ALTERNATIVE PLANNING APPROACH

Response to Comment 85-1

City and County of San Francisco Planning Department
1650 Mission Street, Suite 400
San Francisco, CA 94103

Yosemite Slough Restoration Plan with Lennar Proposed
Bridge Location
Sources: Yosemite Slough Restoration Project, WRA;
Candlestick Point/Hunters Point Shipyard Urban Design Plan, Lennar Urban,
9/25/08.

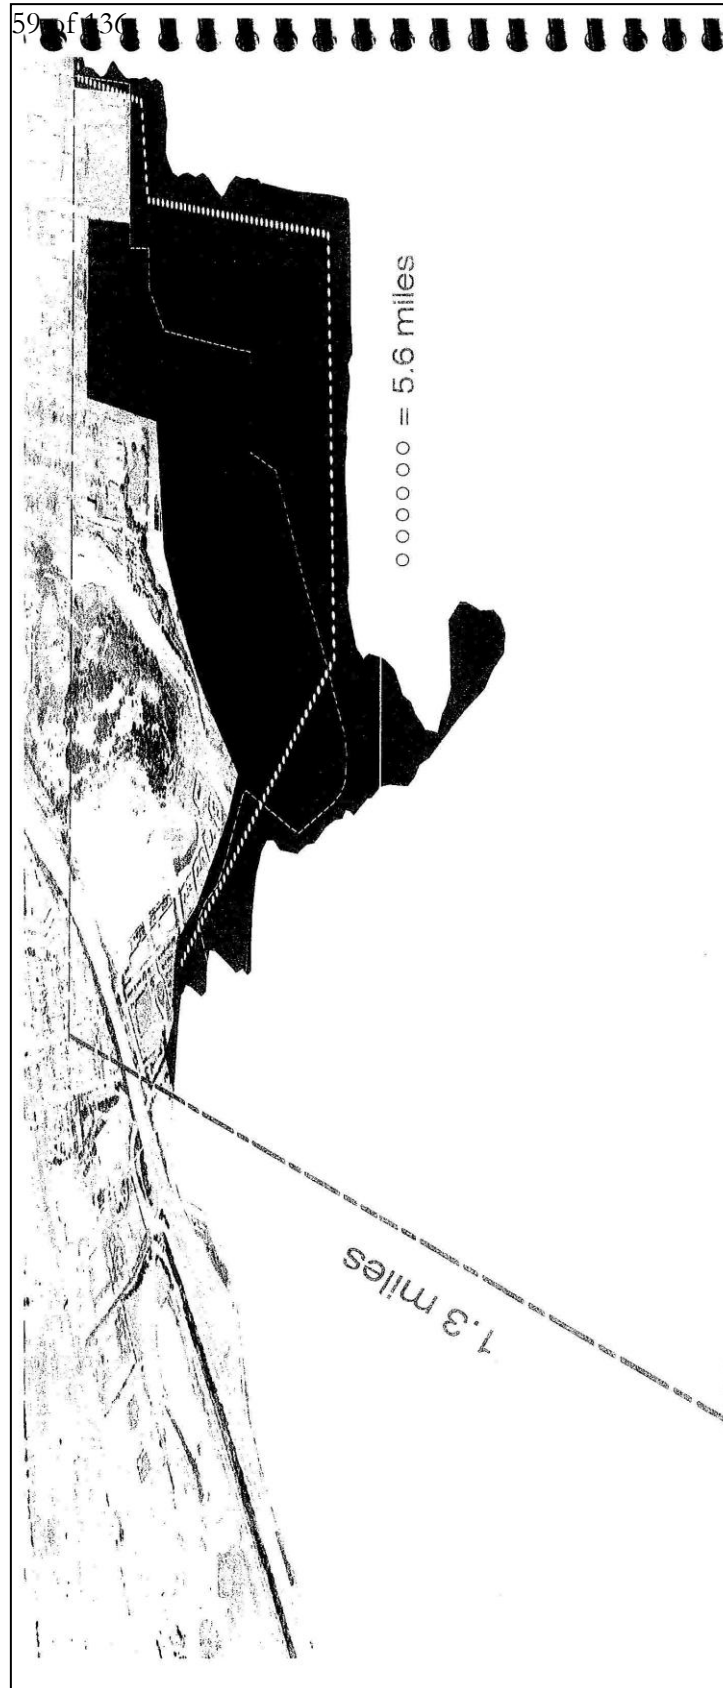
In the context of the city's eastern waterfront Yosemite Slough is unique. It is the only one of the three inlets that is not constricted by major transportation infrastructure. It is surrounded by state park lands and is less developed. It has better water quality and a more naturalistic shoreline. These factors set it apart for its potential for ecological restoration and environmental education. Locating development close to the water's edge and/or constructing a bridge over the slough, as recommended by Lennar, would waste a one-time opportunity to capitalize on this significant biological resource and asset to the community and city.

85-29
cont'd.

Response to Comment 85-29

This comment represents the commenter's opinion regarding what the ecological objectives of planning for the CP/HPS Project should be. This comment suggests that the Project improve existing habitat "by capitalizing on the site's topography, hydrology, and potential connections to nearby habitats." The Project incorporates a number of ecological enhancement measures, as outlined in the Draft Parks, Open Space, and Habitat Concept Plan provided in Appendix N3 of the Draft EIR. These enhancements were developed while taking the site's existing biological resources and physical conditions into account.

As discussed in Responses to Comments 47-5, 47-20, and 47-26 through 47-30, and Master Response 3 (Impacts of the Project on Yosemite Slough [Biological Resources]), the Yosemite Slough bridge will not have a significant impact on the slough's recreational, aesthetic, or biological resources.

ALTERNATIVE STADIUM LOCATION #1
brisbane baylands south

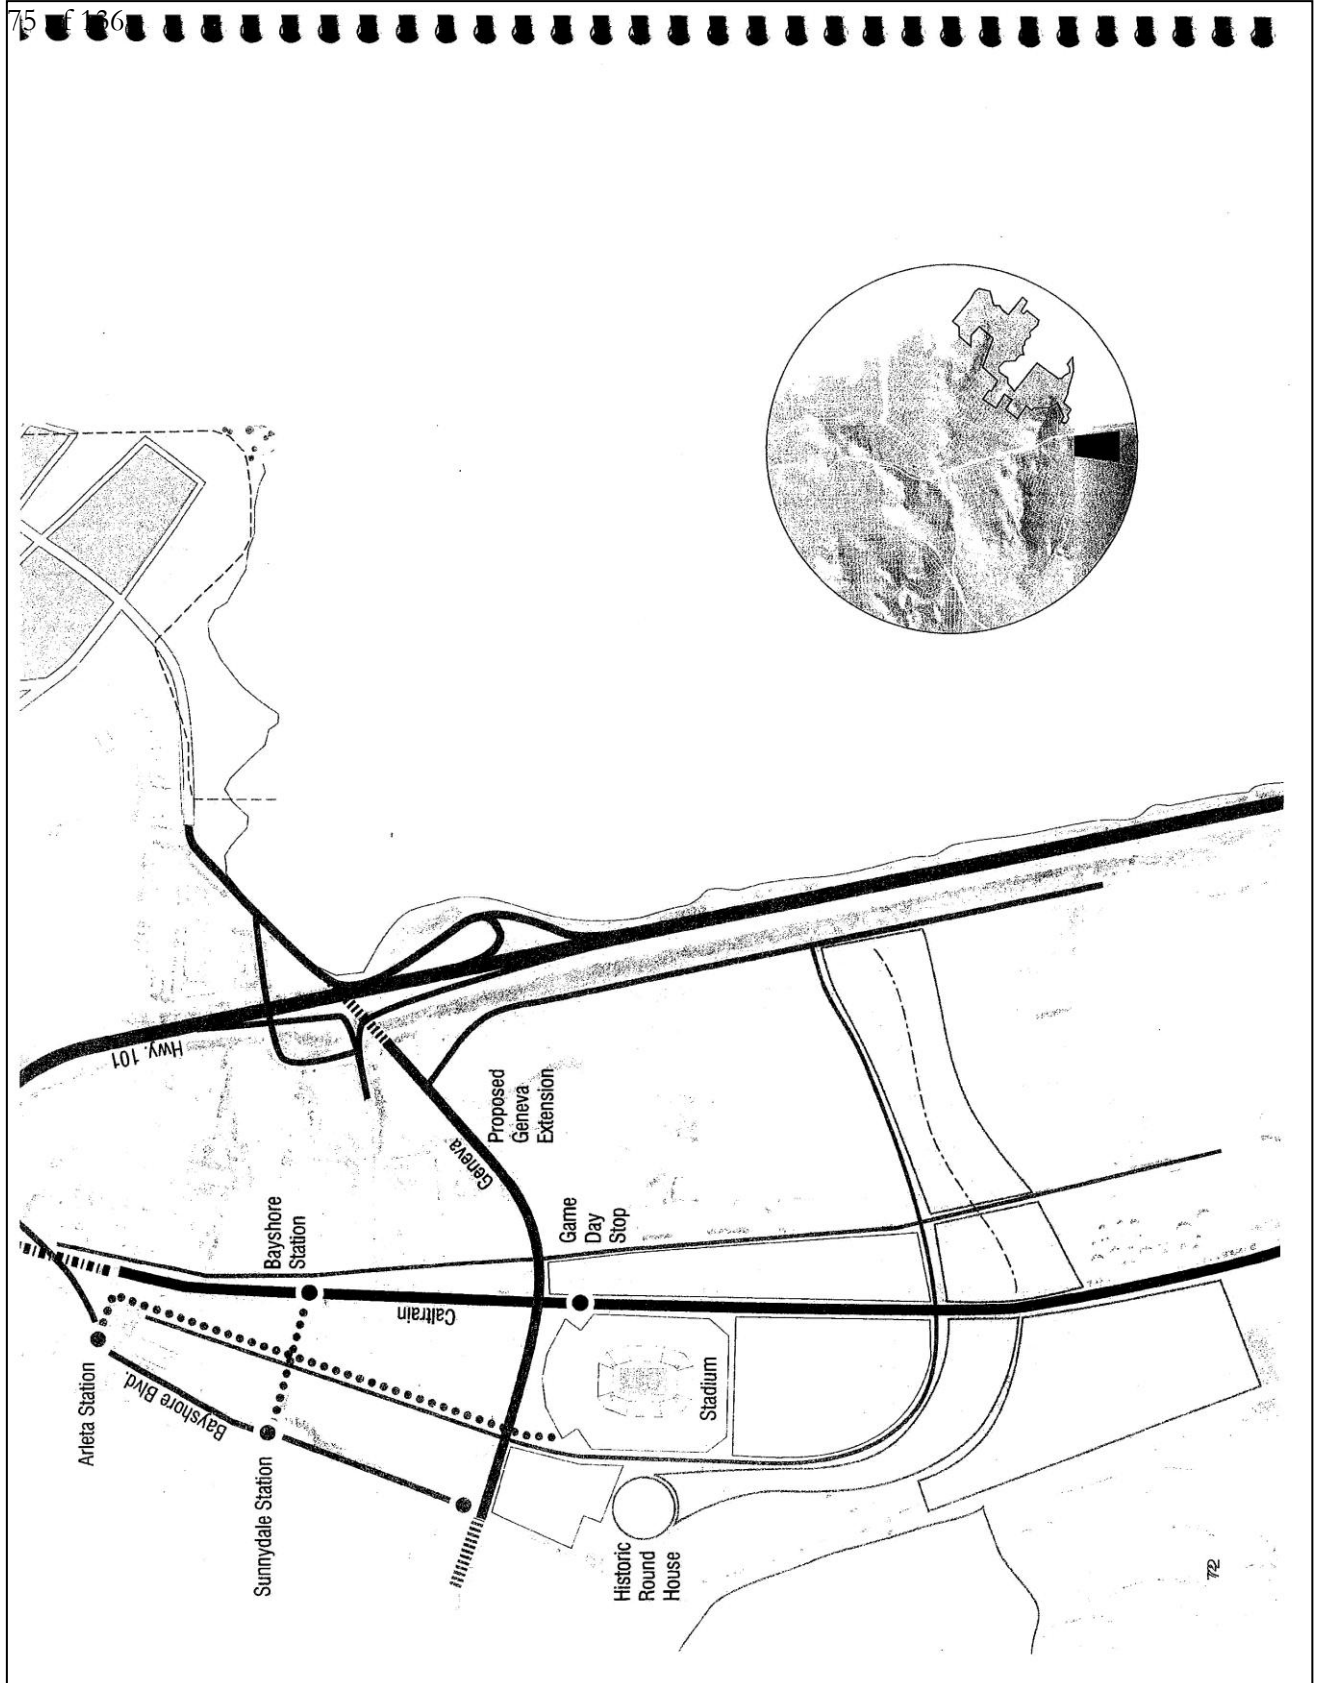
benefits

- large site with existing freeway access
- highly visible from highway 101
- caltrain game day stop could let out at stadium
- minimal traffic impact to residential neighborhoods
- could be planned with adjacent developments

- The Baylands Specific Plan, although not yet formally adopted, does not include a stadium as an allowed use in either the northern or southern portions of the site. Both sites are designated for commercial, office, institutional, and industrial uses. While planning considerations in a particular jurisdiction can evolve over time, it is expected that the range of uses identified in the Phase I Specific Plan reflect Brisbane's long-term planning goals for the Brisbane Baylands, which plans do not include developing a professional football stadium.

- The Brisbane sites are outside of the City and County of San Francisco. Planning review and approval of a stadium in Brisbane Baylands would be subject to City of Brisbane jurisdiction. Neither the San Francisco Redevelopment Agency (Agency), the City and County of San Francisco, nor Lennar Urban would reasonably be able to acquire, control, or otherwise have access to a Brisbane site for the purpose of pursuing such alternative locations. Thus, the Brisbane Baylands sites were determined to be infeasible for development of the stadium, and were rejected from further consideration in the EIR.

ALTERNATIVE STADIUM LOCATION #3
the backlands: piers 90-94

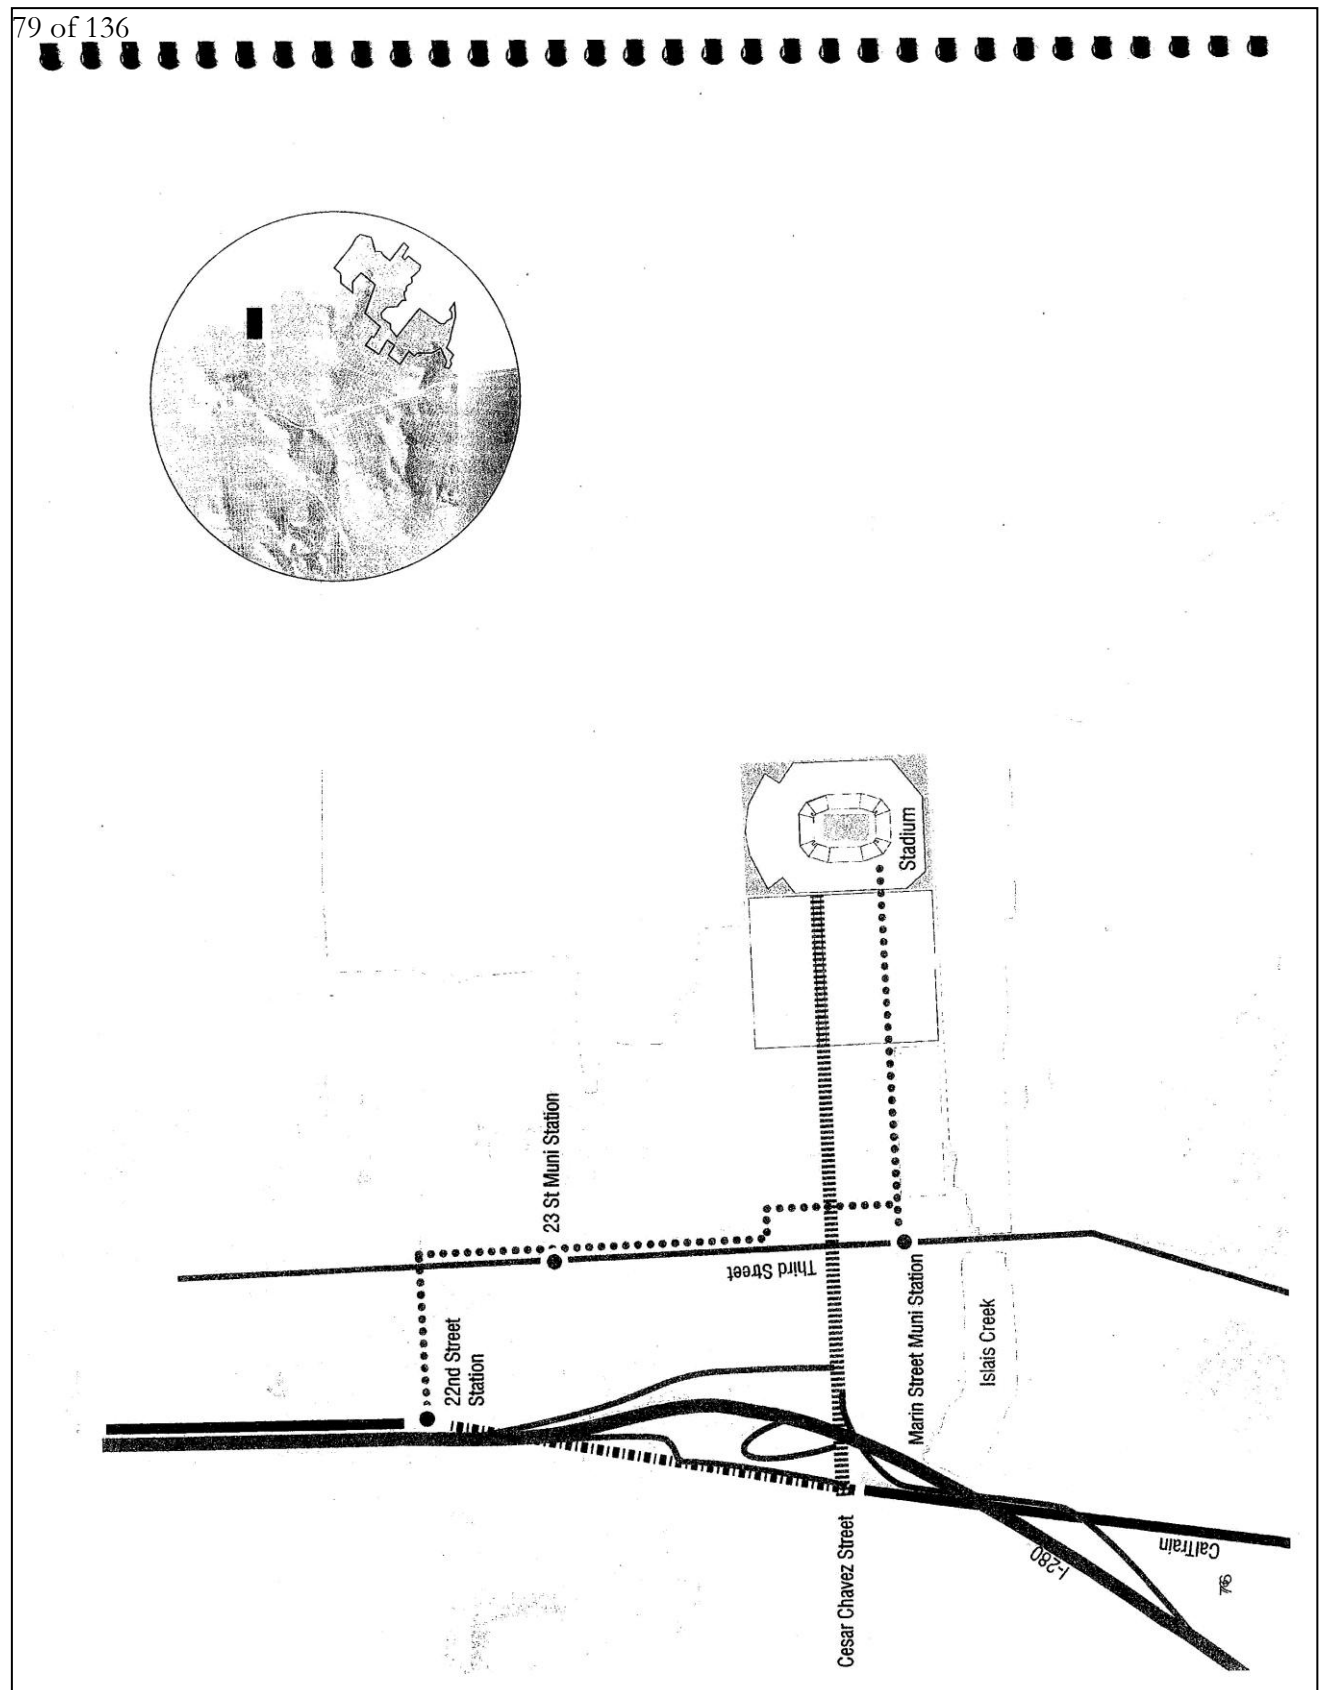
benefits

- flat site owned by port of san francisco
- +/- 1 mile from I-280 access
- walking distance (10 min.) to marin street light rail stop
- connection to caltrain via light rail or walking
- minimal traffic impact to residential neighborhoods

- A stadium would displace maritime-dependent cargo handling and industrial uses not available or feasible elsewhere in San Francisco.
- Sports facilities are not allowable uses at either site under the Waterfront Land Use Plan.

ALTERNATIVE STADIUM LOCATION #4
pier 80

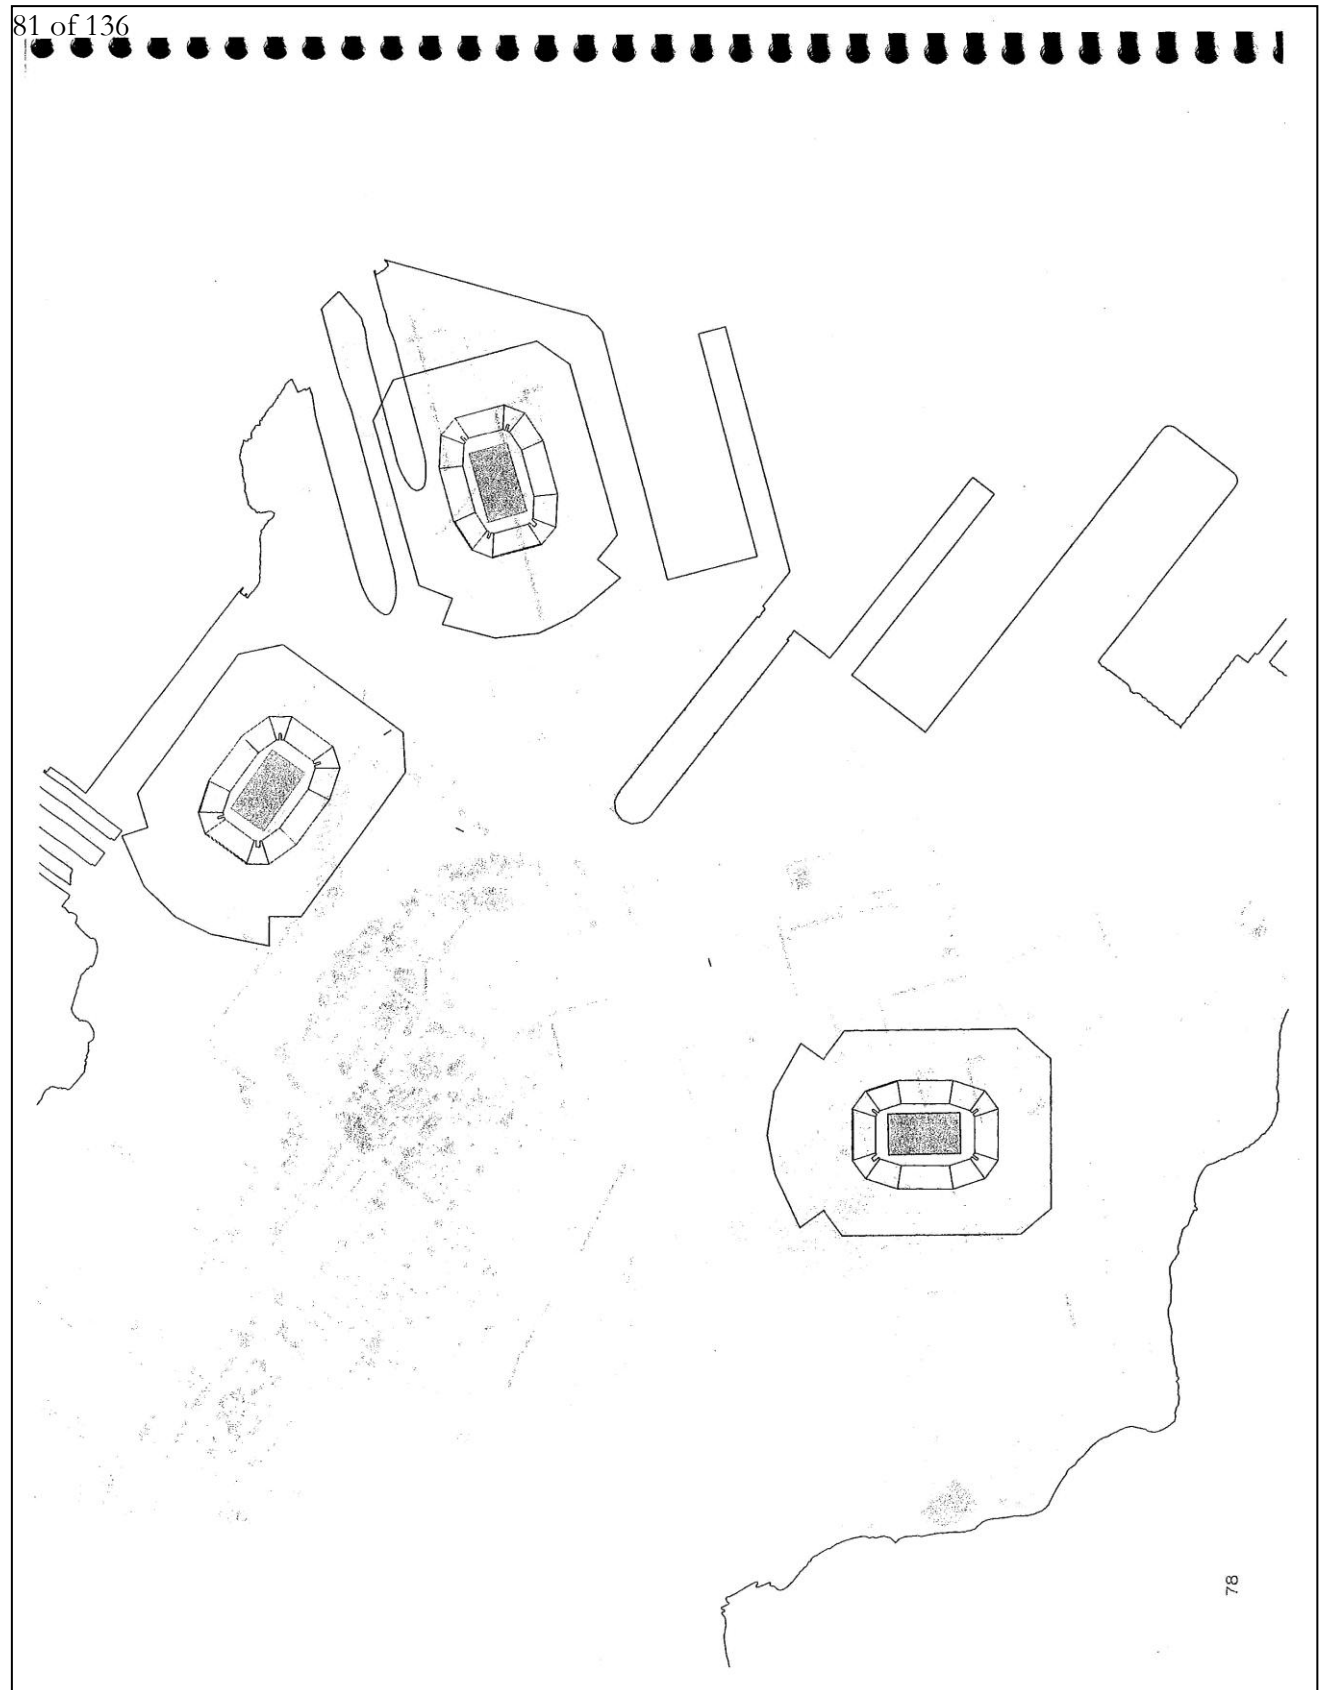
benefits

- flat site owned by port of san francisco
- +/- 1 mile from I-280 access
- walking distance (7.5 min.) to marin street light rail stop
- connection to caltrain via light rail or walking
- minimal traffic impact to residential neighborhoods
